DIAGNOSTIC STUDIES OF HIGHWAY VISUAL COMMUNICATION SYSTEMS

PILOT SITE NUMBER 6

MARYLAND STATE HIGHWAY 26 NEAR BALTIMORE, MARYLAND

TM2(108)-6

STRIP MAP OF STUDY SITE 6 INDICATING DRIVING ROUTES FIGURE 1

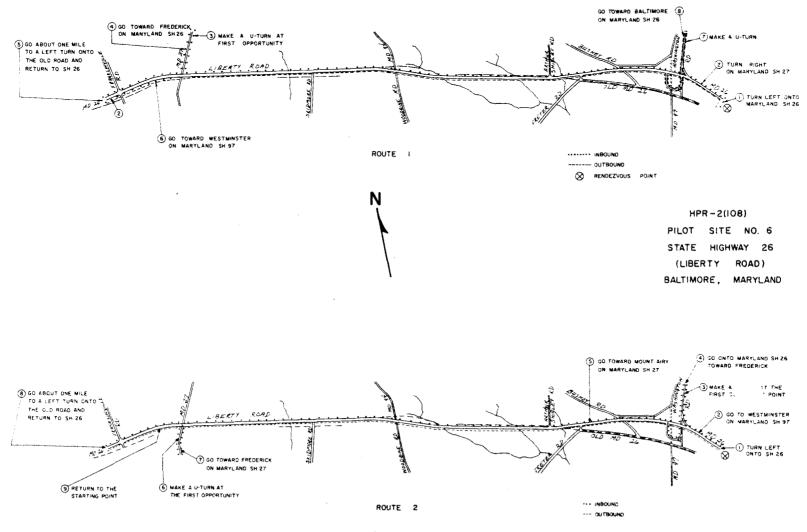
Signing - Several comments were made by the diagnostic team concerning the directional signing at the MD26-MD97 interchange. The general opinion was that the directional signs were entirely too close to the ramps. Several team members felt that the directional sign on the ramp for eastbound MD26 traffic interchanging with MD97 had been improperly placed. This particular sign was located at the midpoint of the ramp and should, perhaps, be located at the ramp's end. All signing along the study section should be reviewed for location and adequacy of size.

The most notable feature of this study section was the apparent lack of proper placement of some directional signs. The inadequacy in the size of some of the signs was also noted. Sign placement and sign size along the study section should be reviewed for adequacy.
